E/ECE/324
E/ECE/TRANS/505 Rev.1/Add.42/Rev.1/Amend.1

Addendum 42: Regulation No. 43

Revision 1 - Amendment 1

UNIFORM PROVISIONS CONCERNING THE APPROVAL OF SAFETY GLAZING MATERIALS

"Rigid plastic glazings other than windscreens

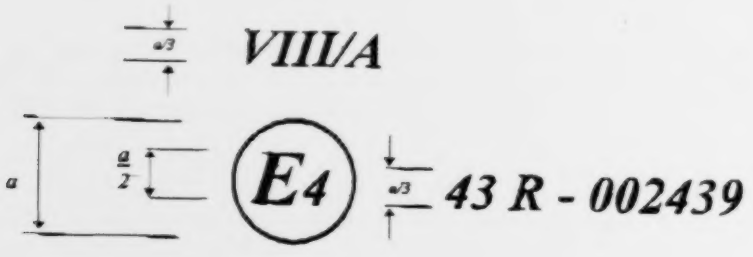
In addition, add at the end of this annex three new examples of approval marks, to read:

The above approval mark affixed to a rigid plastic glazing pane for forward facing panels shows that the component concerned has been approved in the Netherlands (E 4) pursuant to Regulation No. 43 under approval No. 002439. The approval number indicates that the approval was granted in accordance with the requirements of Regulation No. 43.

Flexible plastic glazings other than windscreens

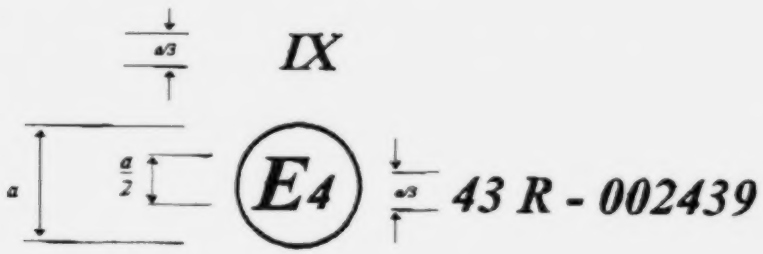
The above approval mark affixed to a flexible plastic glazing pane shows that the component concerned has been approved in the Netherlands (E 4) pursuant to Regulation No. 43 under approval No. 002439. The approval number indicates that the approval was granted in accordance with the requirements of Regulation No. 43.

Rigid plastic double glazed units

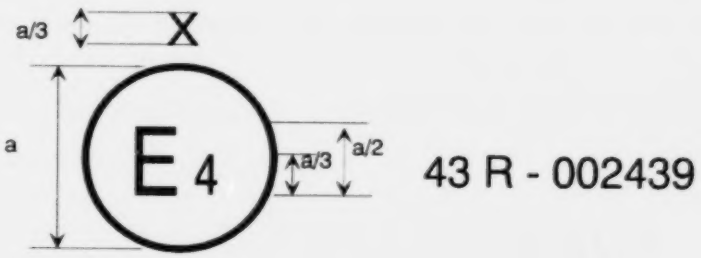
The above approval mark affixed to rigid plastic double glazed units shows that the component concerned has been approved in the Netherlands (E 4) pursuant to Regulation No. 43 under approval No. 002439. The approval number indicates that the approval was granted in accordance with the requirements of Regulation No. 43.

Figure 2.1

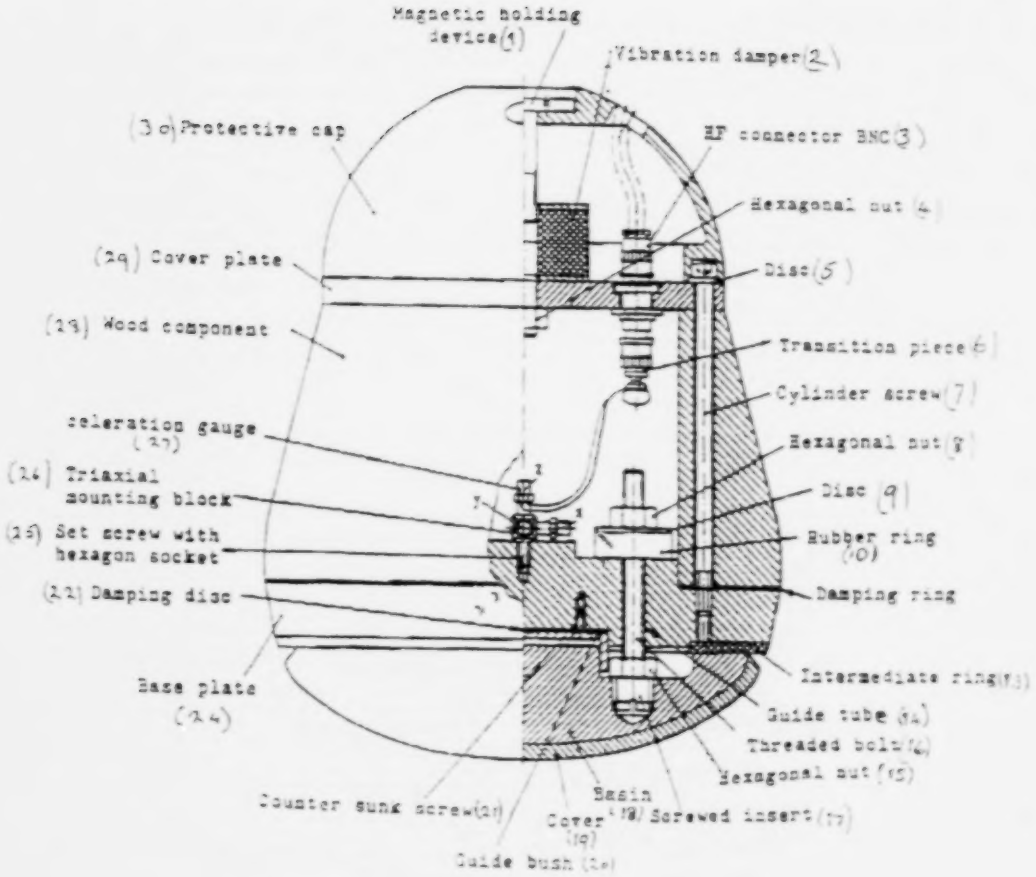
Insert new paragraphs 3.2., to 3.2.6., to read:

In the case of headform tests with simultaneous determination of HIC-values the drop body is the phantom head as in figure 2.1. The total mass of the phantom head should be 10.0 + 0.2/-0.0 kg.

Figure 2.2

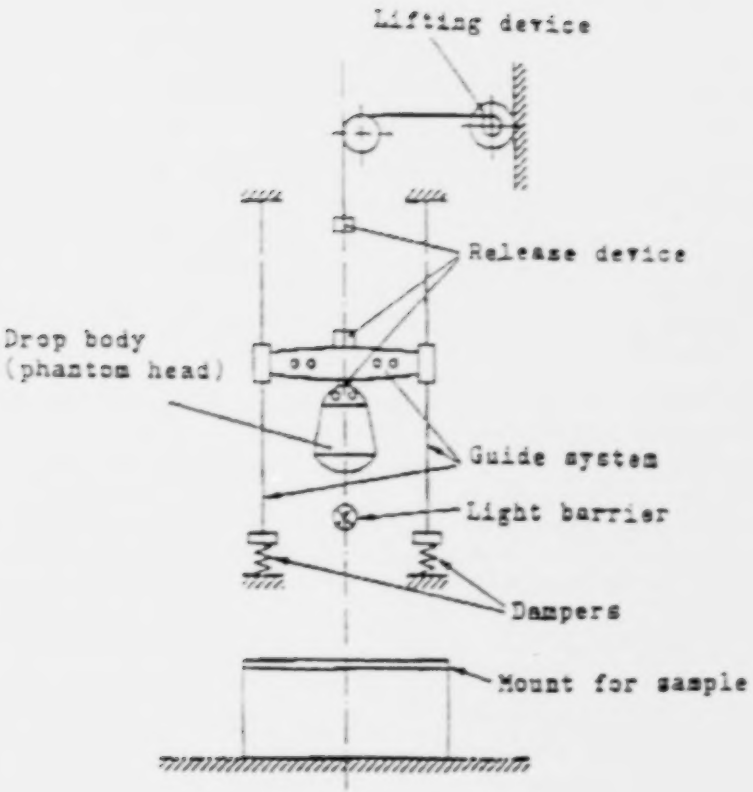
To perform the headform test the phantom head is fixed to the cross arm of the guide system (figure 2.2) and moved to the required drop height by means of a lifting device. During the headform test the cross arm with the phantom head is released. After passing the height adjustable light barrier the phantom head is released from the cross arm, the cross arm's fall is dampened and the phantom head falls onto the sample.
